State of Alaska  
Department of Fish and Game  
Sportfish Division

Nomination Form  
Fish Distribution Database

Nomination # <u>07-238</u>	ADF&G Fisheries Scientist	Date
Revision Year: <u>2006</u>		
Revision to: Atlas <input type="checkbox"/> Catalog <input type="checkbox"/>	ADNR OHMP Operations Mgr.	Date <u>10/29/07</u>
Both <input type="checkbox"/>	<i>[Signature]</i>	Date
Revision Code: <u>F-2</u>	FDD Project Biologist	Date
	Cartographer	Date

SUBJECT: Transmittal Letter for Nomination to Delete a Portion of Ship Creek from the Atlas and Catalog of Waters Important for Spawning, Rearing or Migration of Anadromous Fishes

George Inlet

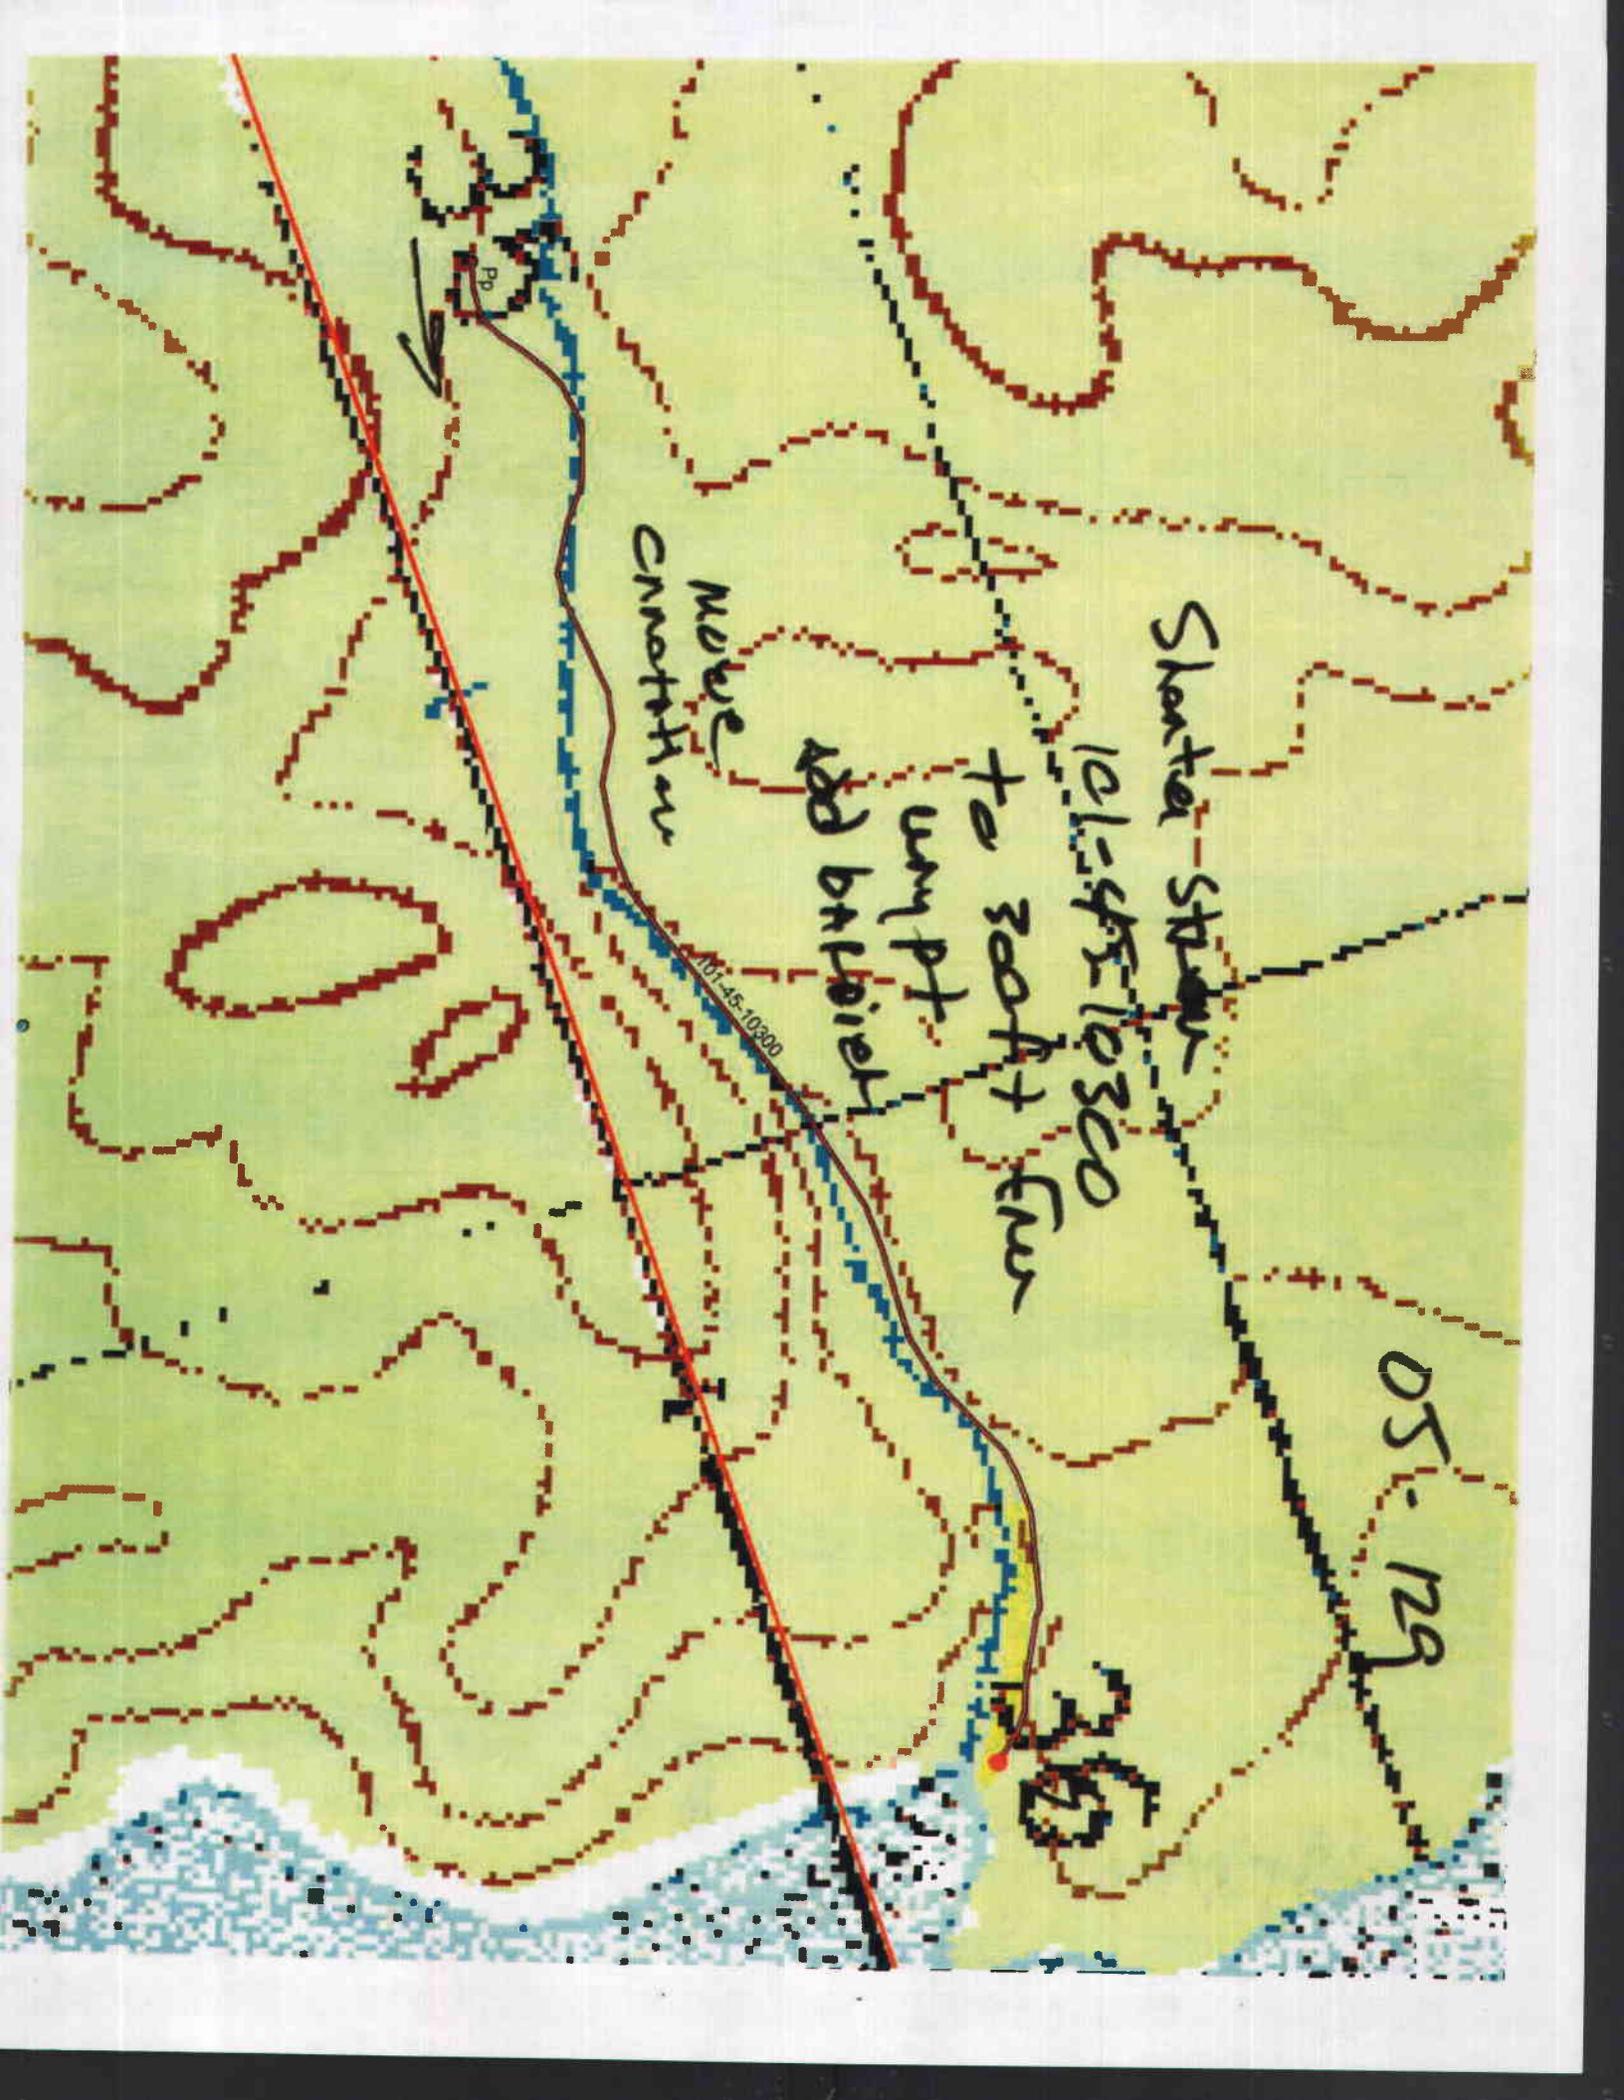
**Actions:** Remove the upstream segment of 101-45-10300, 300 feet upstream of GPS Point 133.51747 W, 55.50133 N.

Remove upstream segment 300 Ft above way pt  
and barrier

103-50-10220

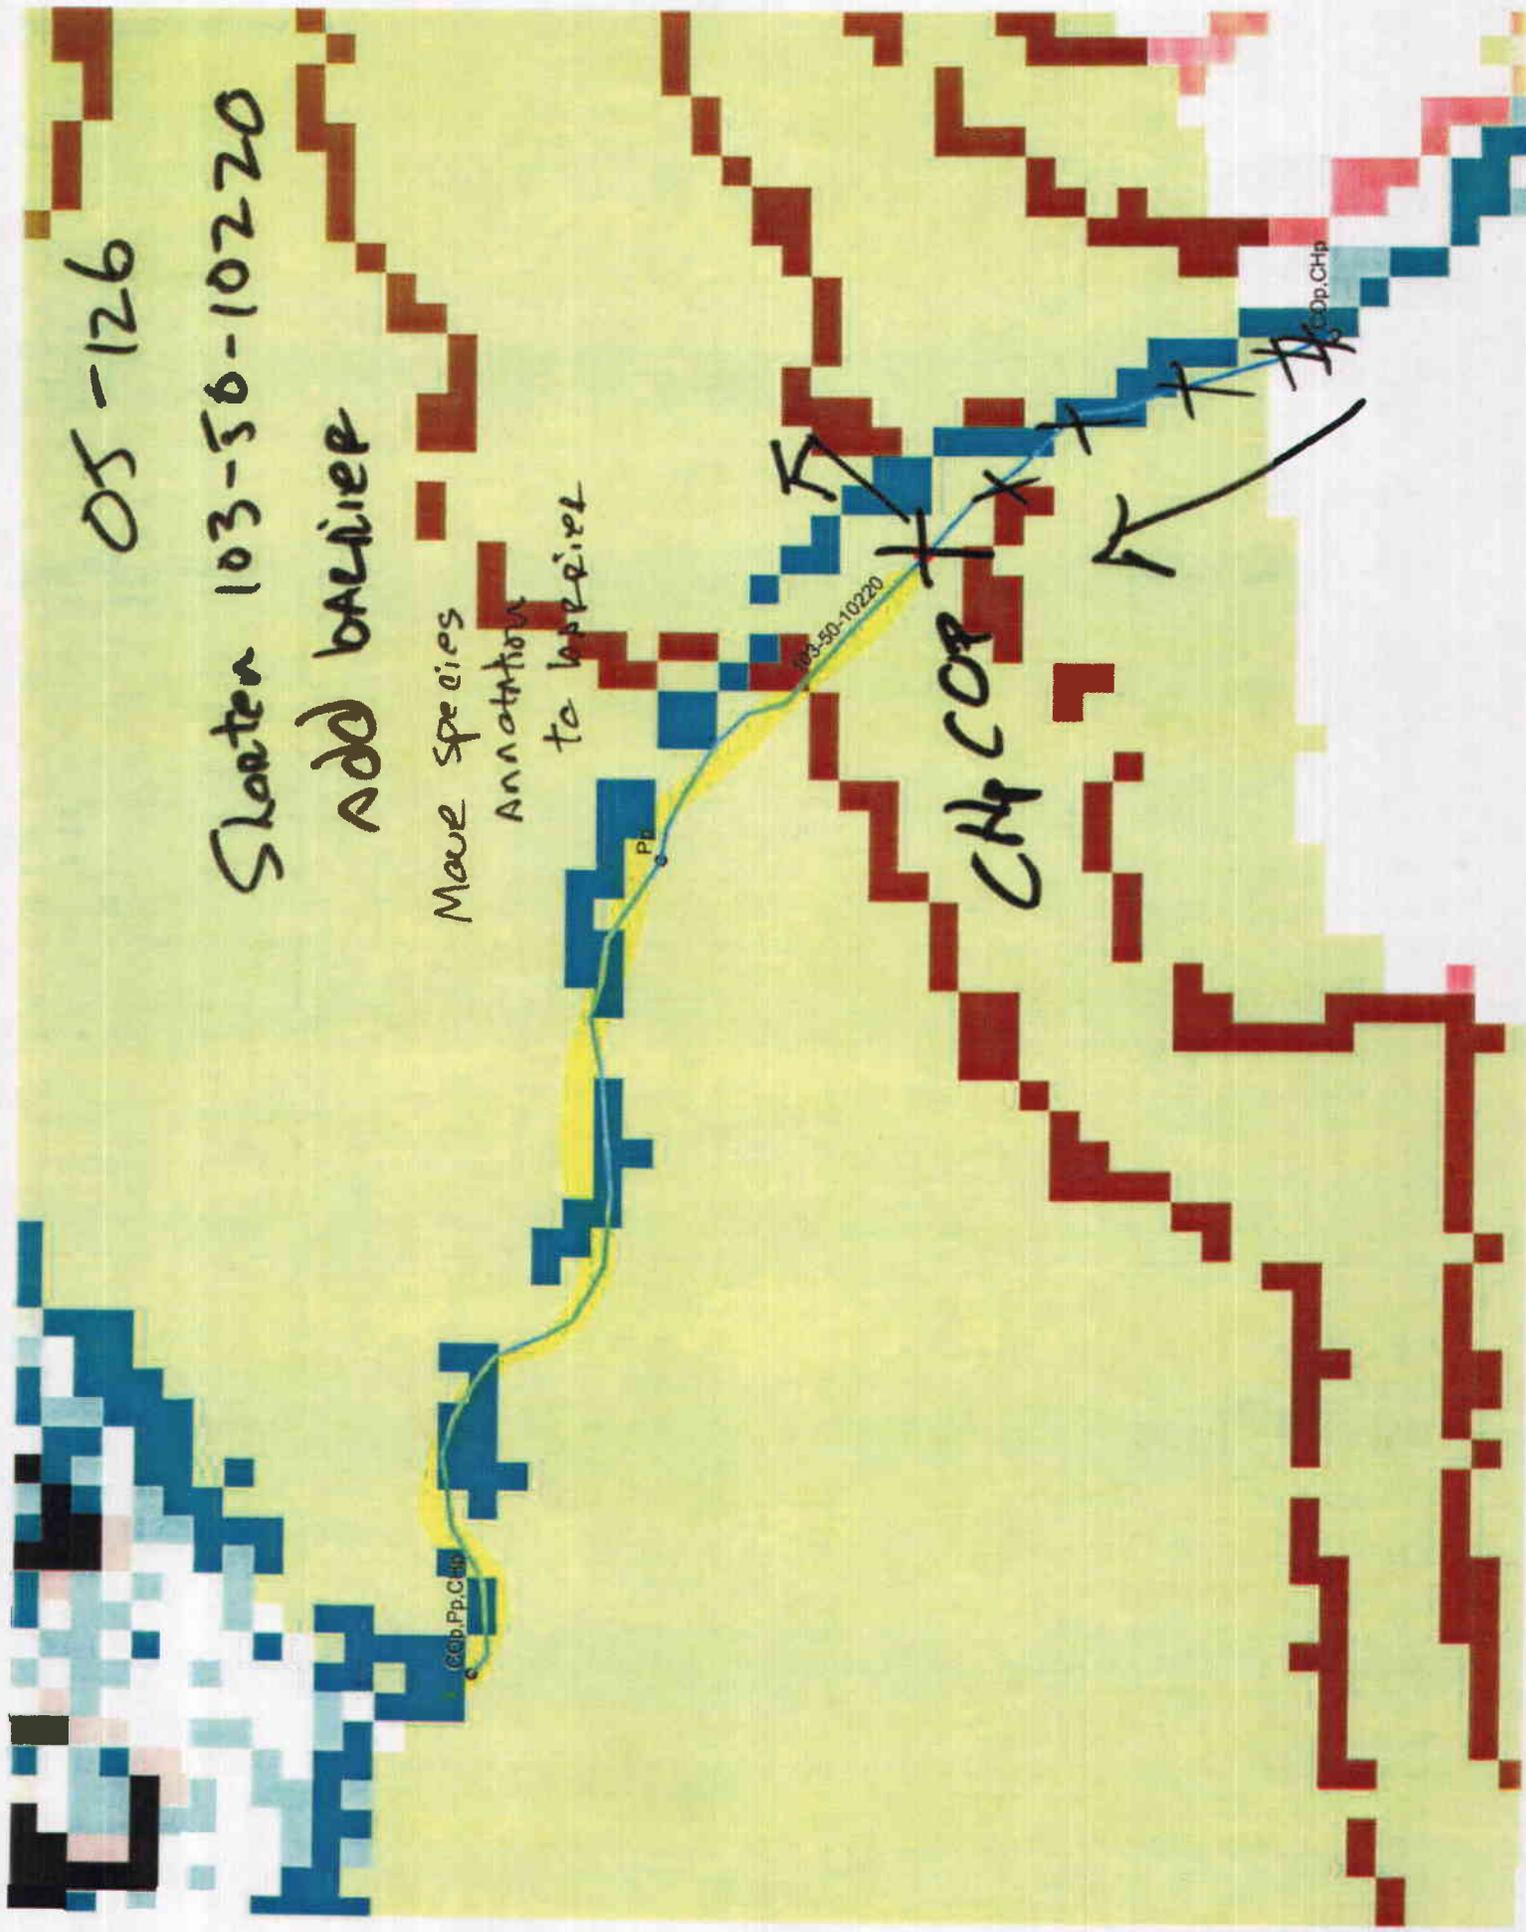
**Actions:** Remove the upper limits of 103-50-10220 beyond 133.23337 W, 55.34289 N.

Shastou Stream to pt indicated, Add barrier

ADD BARRIER

Move Species  
Annotation  
to barrier
